UNITED STATES  
NUCLEAR REGULATORY COMMISSION  
WASHINGTON, D. C. 20555

CALVERT CLIFFS NUCLEAR POWER PLANT, UNIT NO. 1

AMENDMENT TO FACILITY OPERATING LICENSE

Amendment No. 171  
License No. DPR-53

FIGURE 3.4.9-1

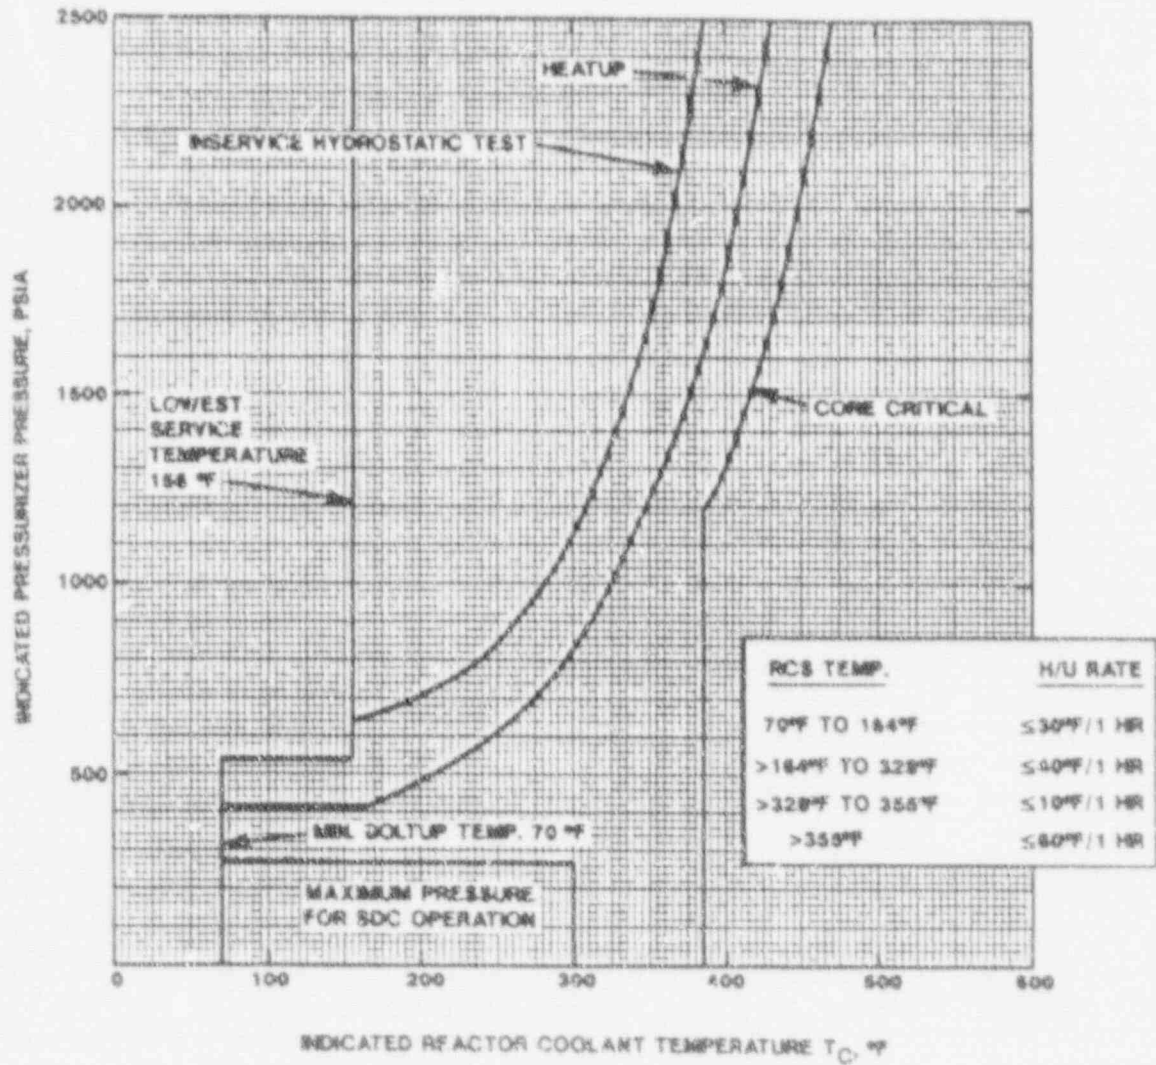
3.4.9.1 The Reactor Coolant System (except the pressurizer) temperature and pressure shall be limited in accordance with the limit lines shown on Figures 3.4.9-1 and 3.4.9-2 during heatup, cooldown, criticality, and inservice leak and hydrostatic testing with:

<u>Maximum Allowable Heatup Rate</u>	<u>RCS Temperature</u>
30°F in any one hour period	70°F to 164°F
40°F in any one hour period	> 164°F to 328°F
10°F in any one hour period	> 328°F to 355°F
60°F in any one hour period	> 355°F

FIGURE 3.4.9-2

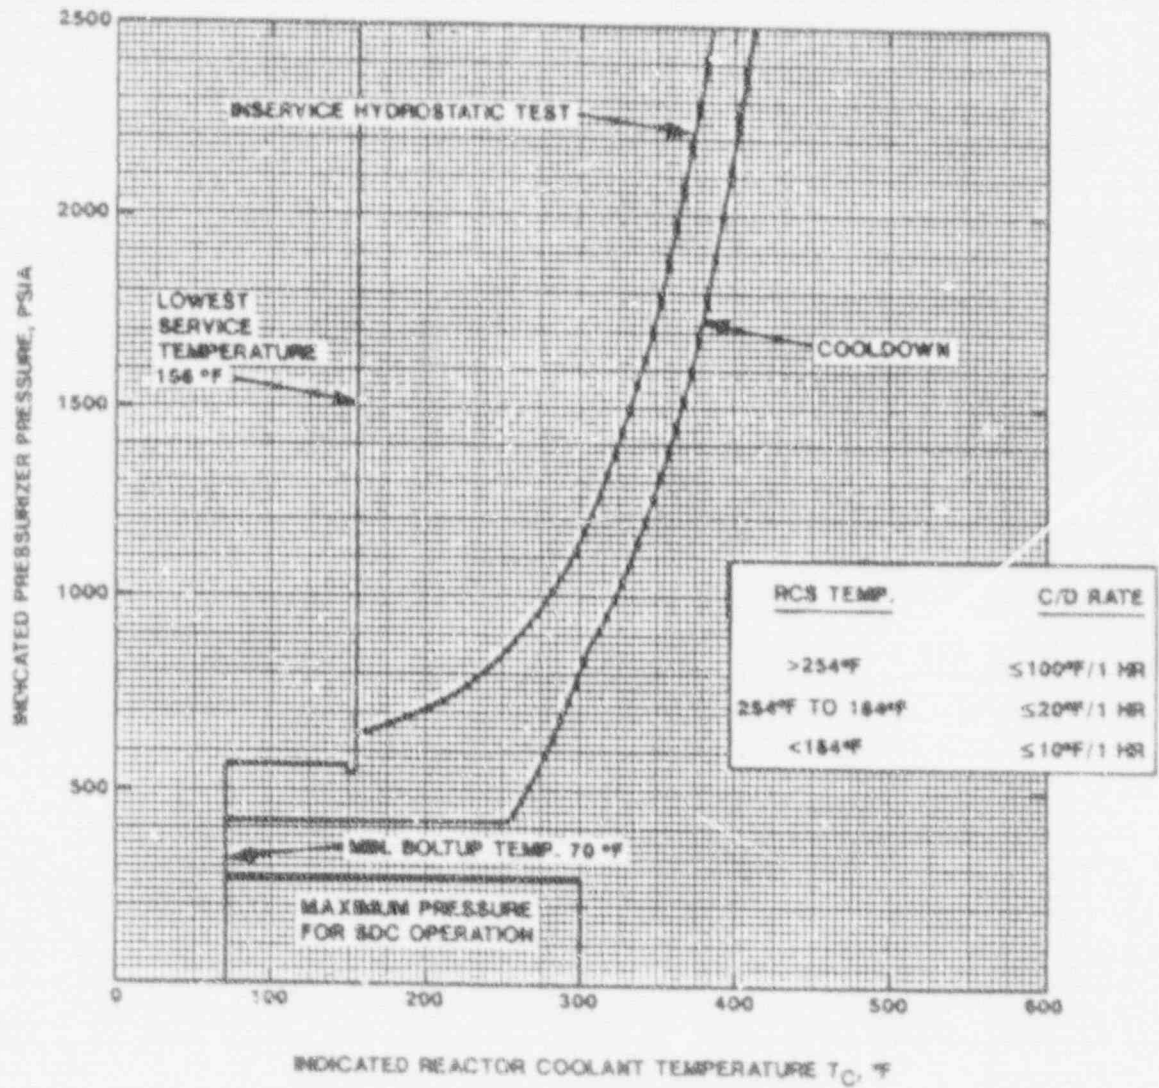
<u>Maximum Allowable Cooldown Rate</u>	<u>RCS Temperature</u>
100°F in any one hour period	> 254°F
20°F in any one hour period	254°F to 184°F
10°F in any one hour period	< 184°F
